ST. CHARLES SINCE 1834	**HISTORIC PRESERVATION COMMISSION AGENDA ITEM EXECUTIVE SUMMARY**			
	Agenda Item Title/Address:	COA: 225 W. Main St.		
	Proposal:	Changes to façade project		
	Petitioner:	Brad Colby, BC Carpentry and Ed Seaman		
	Please check appropriate box (x)			
	PUBLIC HEARING		**MEETING 11/15/17**	**X**

Historic Commission Review

Job: Home Brew Shop complete remodel
Address: 225 W Main St.
St. Charles, Il 60174

Structural and Exterior remodel

James Hardie Lap siding and trim option

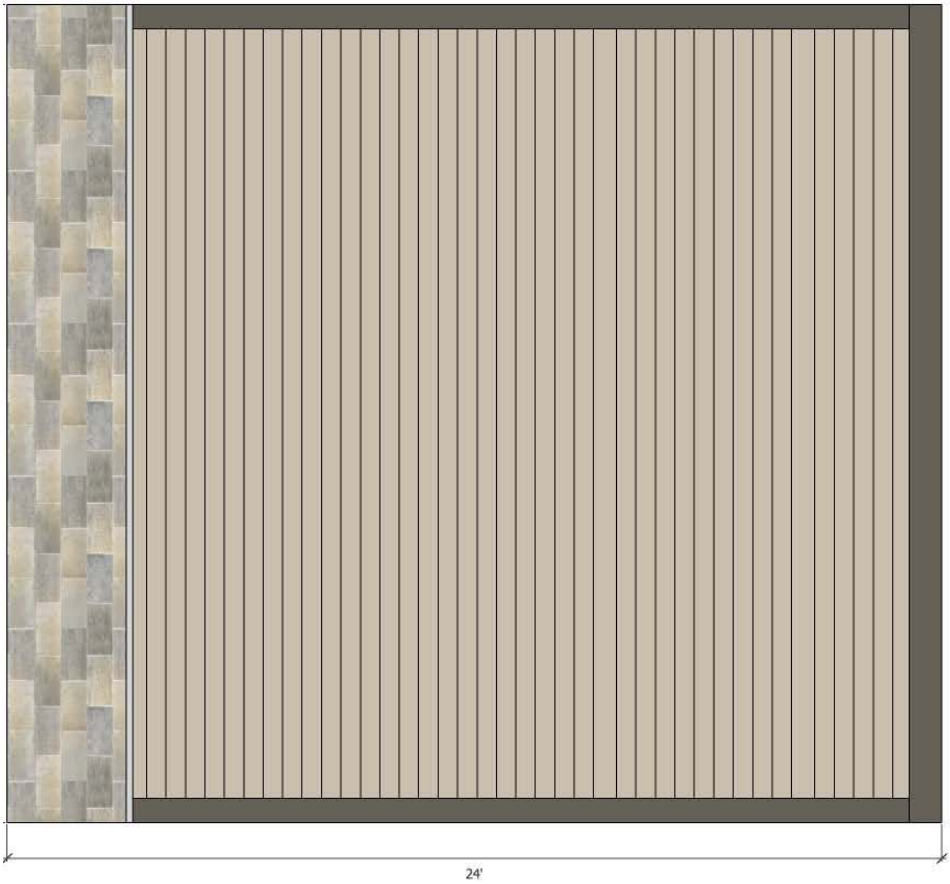
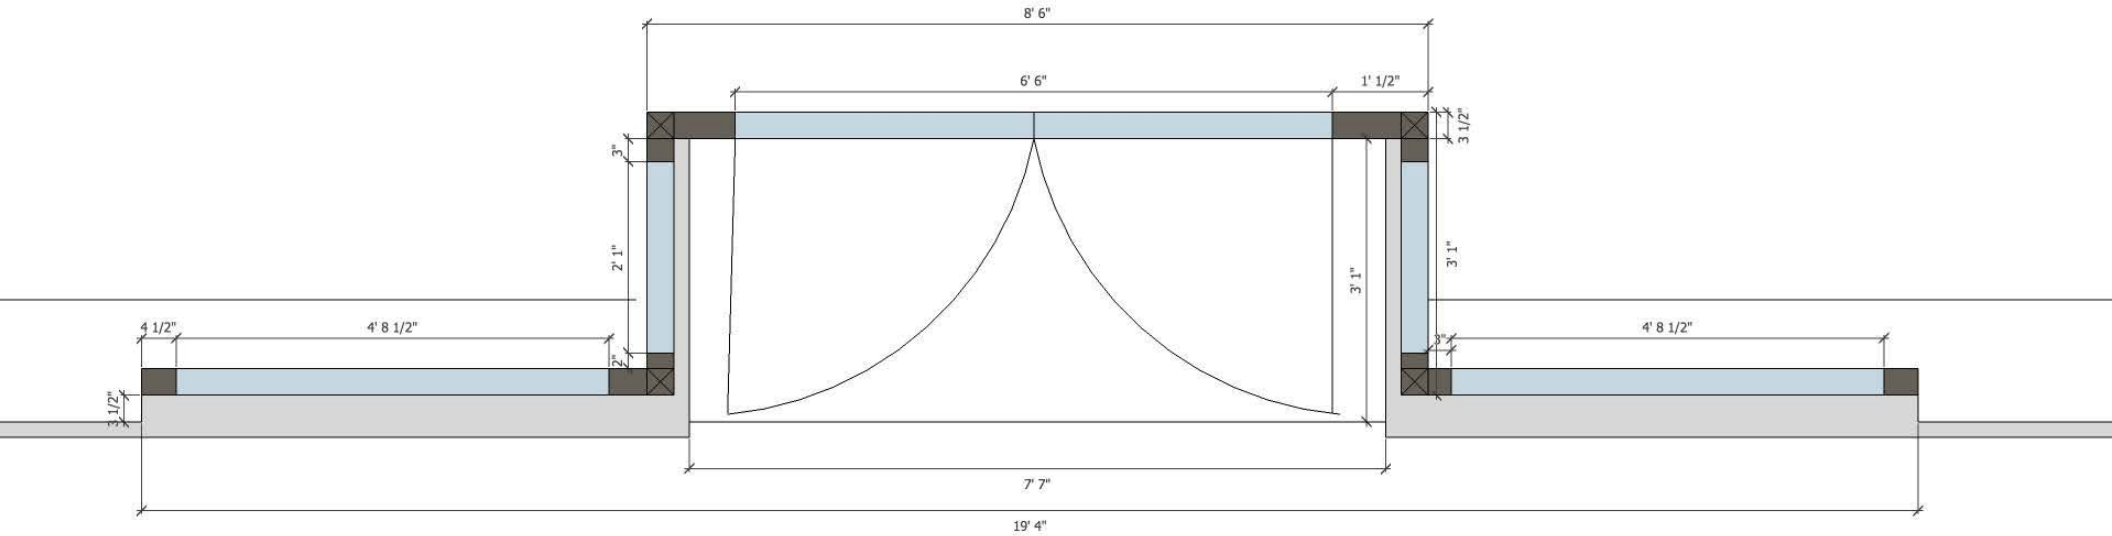
- **Eliminate EFIS, and replace exterior cladding on west and south elevations with 3/4" treated wood furring rain screen and James Hardie Fiber cement siding and trim products.**
  - **See 2 provided elevations for options.**
- **In leu of transoms, I propose to trim areas above windows with Hardie products to simulate the original look of the building. Transom will be provided over door, level with windows.**
